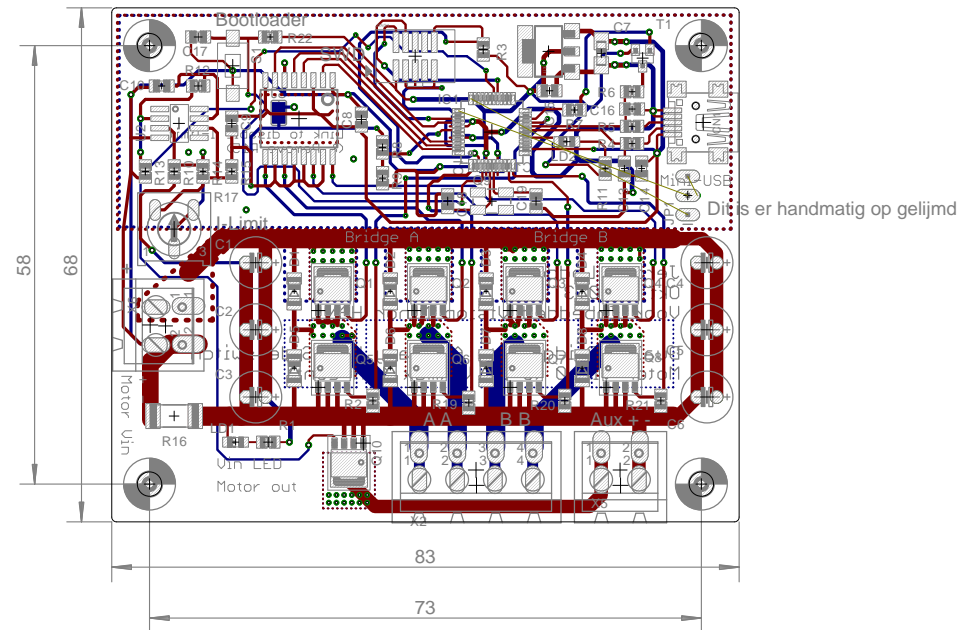
Feature: Dual connector for Phoenix MSTB and cheap chinese screw terminal  
 Improvement: Move crystal Q9 away from Vin current conductor  
 Improvement: Do not run FET Gate traces parallel to current Vin conductor
